766 Ground Water Quality Study For The
Richmond Semi-Depressed Section
04-CC-17

04-CC-17, PM 1.3 to 3.9
47th St. to 6th St.
04209-108701
Lab Auth 652907
August 1979

SUPPLEMENT TO THE
REPORT
OF
GROUND WATER INVESTIGATION
FOR THE
PROPOSED
RICHMOND SEMI-DEPRESSED SECTION
04-CC-17
(GROUND WATER QUALITY STUDY)

FIGURE 2

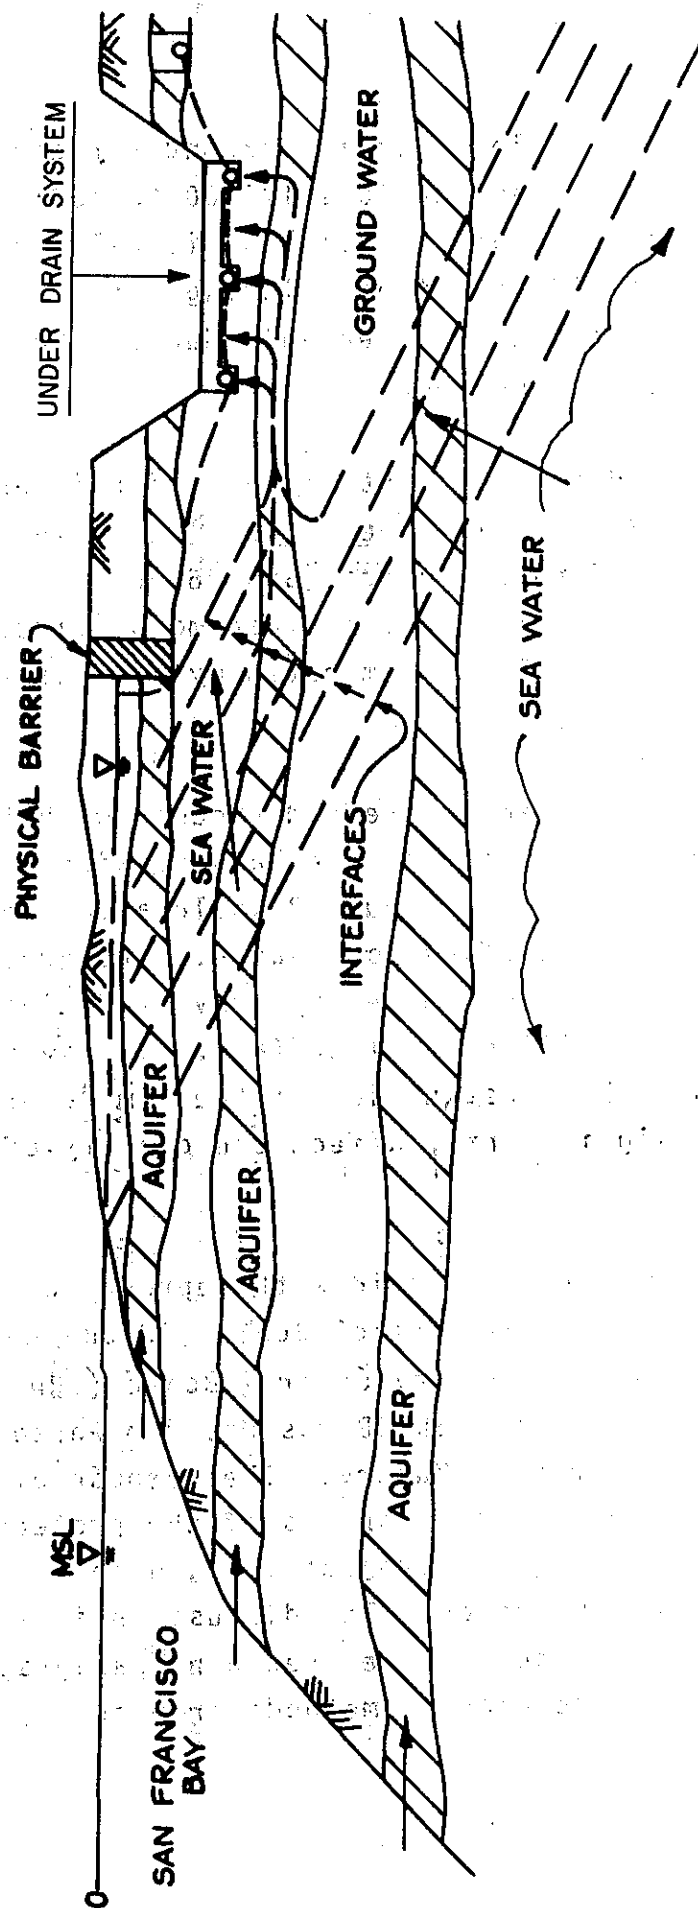
Caltrans could induce some added seawater intrusion within the project area; which was, however, considered to be of no significant concern. The consensus was that there would be no damage to the aquifers in the Contra Costa Ground Water Basin as a result of the freeway construction. Mr. Richard McMurtry also suggested a monitoring system to evaluate the effects of the proposed construction. Mr. McMurtry noted no problems as far as SWRCB and CRWQCB are concerned and asserted he would confirm this decision by letter.
